标题：发动机安装套装表		
AG-SIL-2021-05-CN		发布日期： 2021 年 8 月 30 日
适用性		
旋翼机类型与型号： MTO Sport, Calidus, Cavalon & MTO2017	受影响系列号： 所有旋翼机型，所有发动机类型	
以目前或后续版本的维护保养手册为准。		见 AutoGyro 网站。
此表是 AutoGyro GmbH 针对产品使用中发现需要采取遏制或整改措施的问题作出的回应，或作为飞机改造公司的服务信息。 要寻求帮助请拨打 49(0)5121 88056-00 联系 AutoGyro, 或发送电子邮件至 airworthiness@auto-gyro.com 。

本《服务信函》的原因及概述

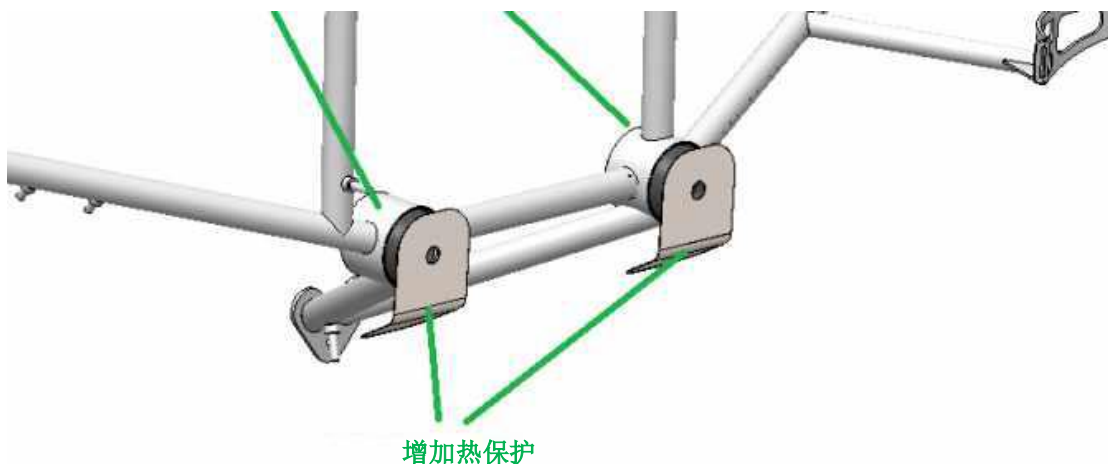
注意：对于装有涡轮增压的发动机，在左下安装螺栓的末端和涡轮外壳之间必须留有最小 2 毫米的间隙。
